**CORRESPONDENCE COVER SHEET  
WASTE PERMITS DIVISION  
TEXAS COMMISSION ON ENVIRONMENTAL QUALITY**

Date: April 25, 2019  
 Facility Name: City of Kingsville Landfill  
 Permit or Registration No.: MSW 235-C

Re: City of Kingsville Landfill – Kleberg County  
Municipal Solid Waste (MSW) - Permit No. 235C  
Permit Amendment Application – Notice of Deficiency  
Tracking No. 23301130, 23458984, and 24040819; RN102334570/CN600674246

On behalf of the City of Kingsville and in response to the Texas Commission on Environmental Quality's (TCEQ) March 27, 2019 Notice of Deficiency (NOD) letter, we hereby submit the enclosed response regarding the Permit Amendment Application for the above referenced MSW facility.

FIGURE:  
 III.5-A.5

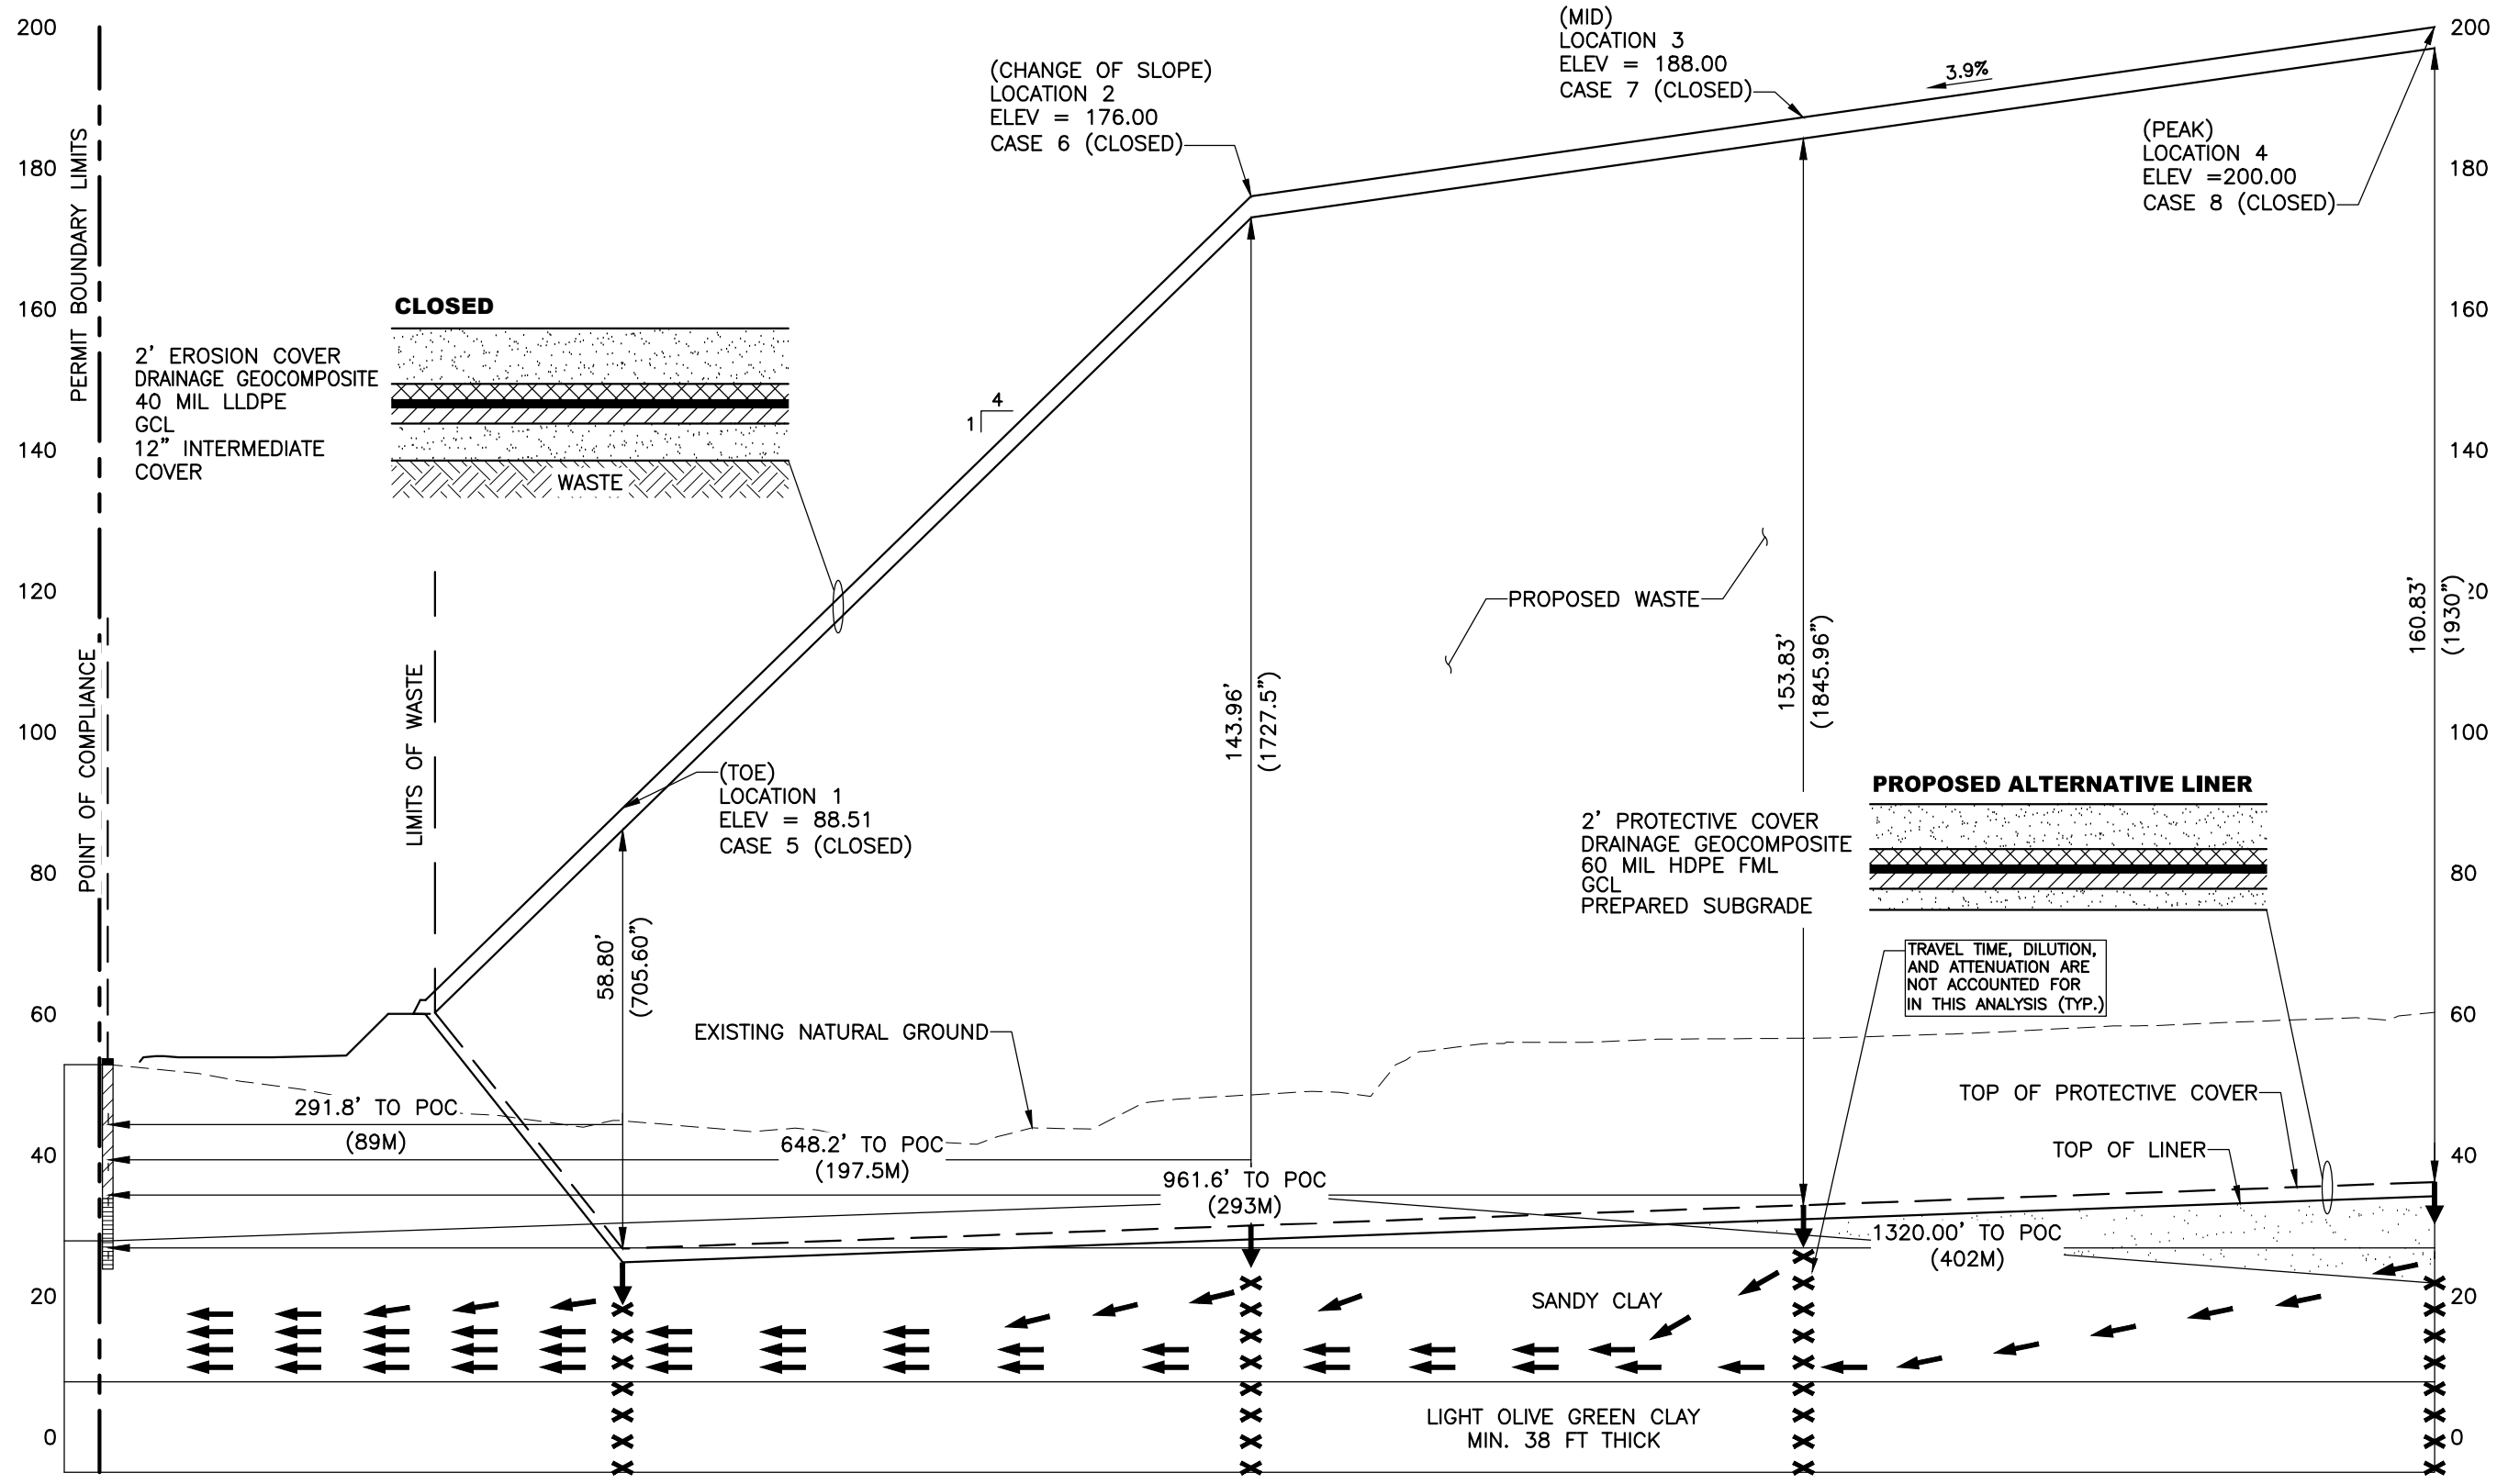
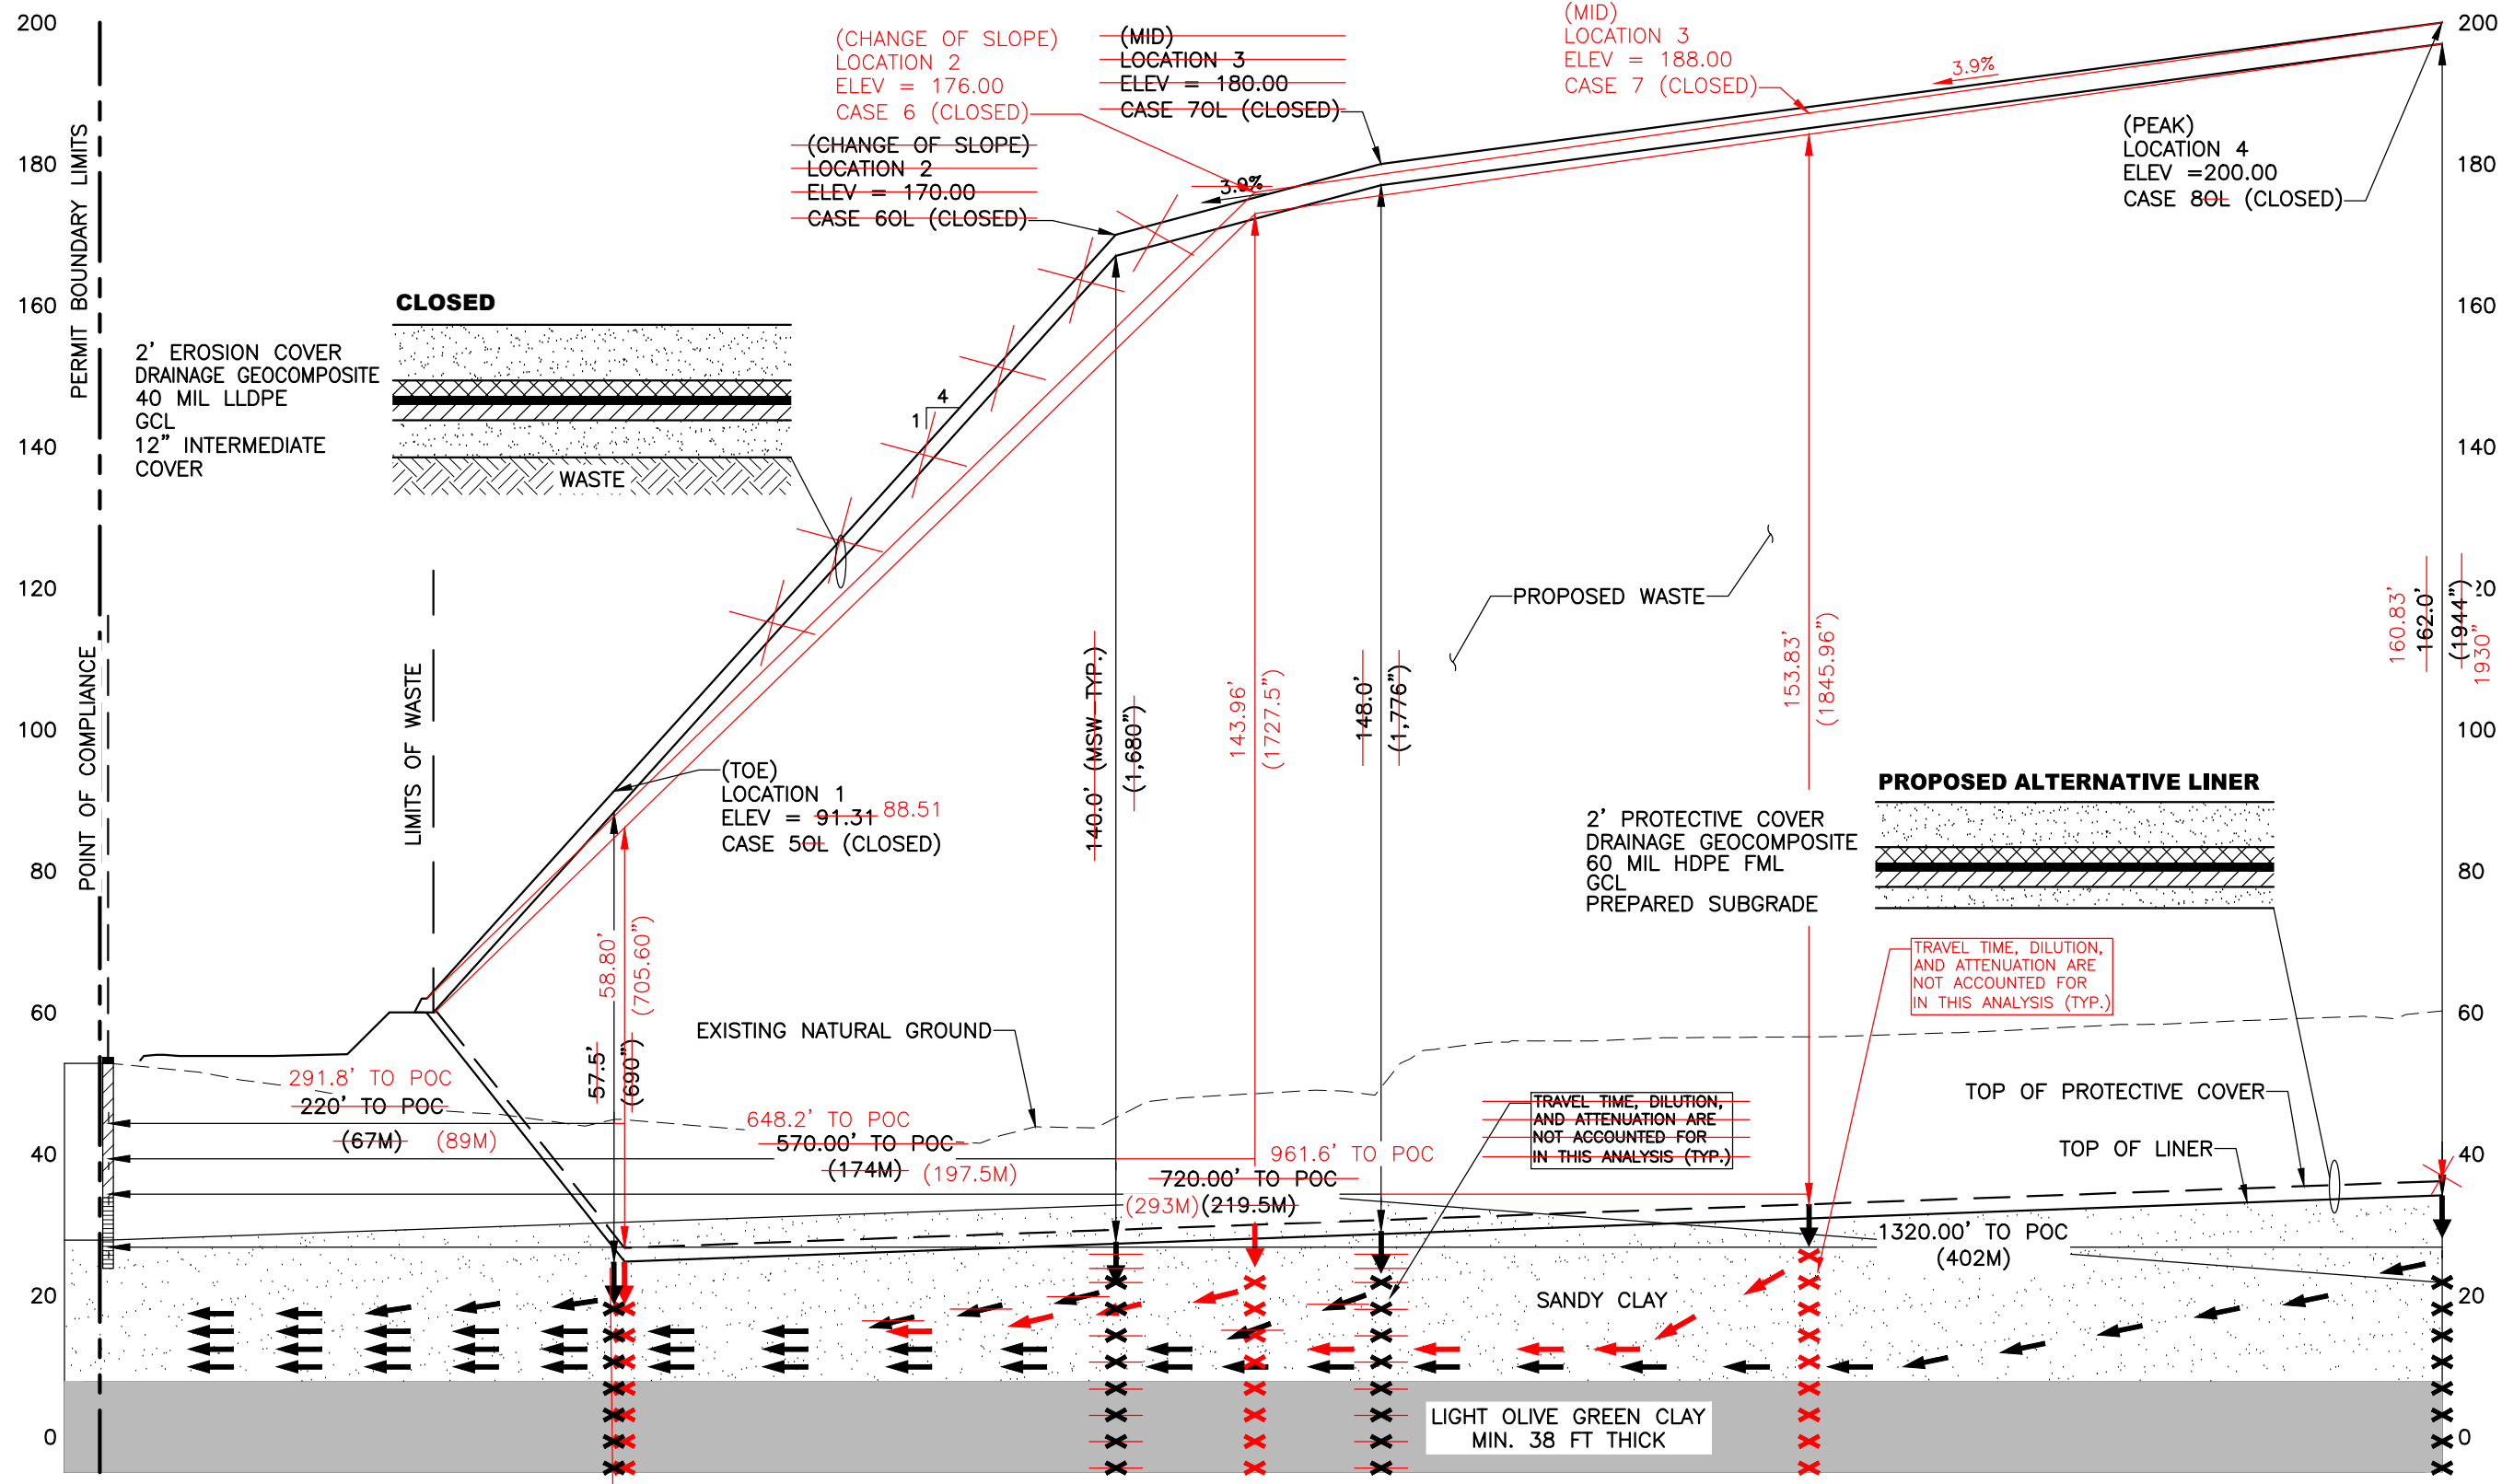
NT18	379	Part III	330.335	Vol. 4, Part III, Att. 5, Figs III.5-A.5 through A.8	Incorrect	Correct the labels and the distance to POC for the cases that do not include overliner.	The labels and the distance to POC for the cases that do not include overliner have been corrected. This affects Figures III.5-A.1 through A.6. It does not affect overliner Figures III.5-A.7 & A.8.
NT19	379	Part III	330.335	Vol. 4, Part III, Att. 5, Appendix C.4, p. 1	Incorrect	Correct the information for Cases 3OL and 4OL that indicate pre-Subtitle D waste above the overliner.	Vol 4, Part III, Att. 5, Appendix C.4, p.g.-1 has been corrected to indicate pre-Subtitle D waste is below the overliner.
NT20	379	Part III	330.335	Vol. 4, Part III, Att. 5, Appendices C.6 and C.7	Ambiguous	Revise the tables of Multimed aquifer-specific data to clearly reference the information reproduced from existing permit 235B in Appendices C.7.1 and C.7.2, and remove the note at the bottom regarding Evangeline Aquifer.	The tables of MULTIMED aquifer-specific data in Part III, Att. 5, Appendices C.6 and C.7 have been corrected to clearly reference the information reproduced from existing permit 235B in Appendices C.7.1 and C.7.2. In addition, the note at the bottom regarding Evangeline Aquifer has been deleted.
